Response to Referee Comments - WES Discussions

Analyzing the Impact of Aeroelastic Model Fidelity on Control-Co Design Optimization of Floating Offshore Wind Turbines

Robert Behrens de Luna, Francesco Papi, David Marten, Christian Oliver Paschereit

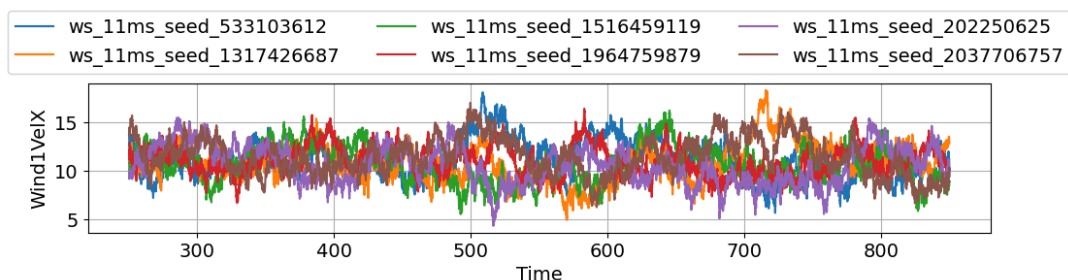
3. “all five optimizations” – these have not been defined yet?

Response: We thank the reviewer for pointing this out. The sentence was revised [Line 257] to clarify that all optimizations used identical QBlade models, except for the selected wake and beam models. The detailed introduction of the five optimization cases is provided in Section 4 (Results, Table 4).

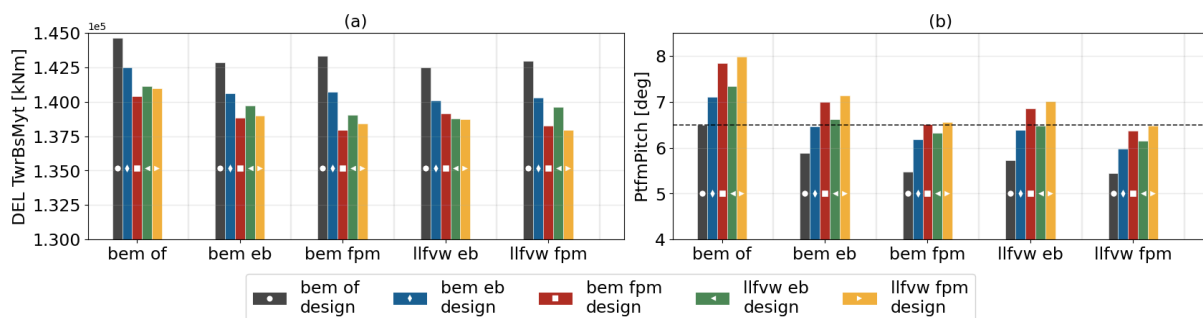
3. “rediction but also enables more effective optimization” – this could only be stated if the initial and final designs resulting from each of 5 optimizations were evaluated with one consistent model – otherwise, it is impossible to compare which optimisation led to a better design.

Response: We thank the reviewer for pointing this out, and we have added a subsubsection on a cross-comparison, including the figure below (Section 4.2.4 “Cross-Evaluation of Design Outcomes”). This comparison shows how the final outcomes of the different optimizations compare when analyzed with the same aeroelastic model.

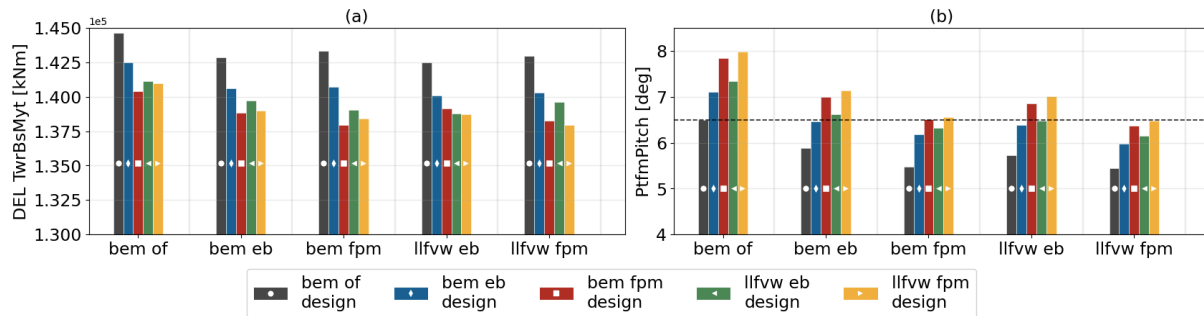
It might be informative to compare the results of a low-fidelity optimized design when re-evaluated using a higher-fidelity model.

Response: We thank the reviewer for pointing this out. This point was also mentioned by the other reviewer. We have added a cross-comparison in section 4.2.4 [Line 441] that includes the figure below. This comparison shows how the final outcomes of the different optimizations compare when analyzed with the same aeroelastic model.
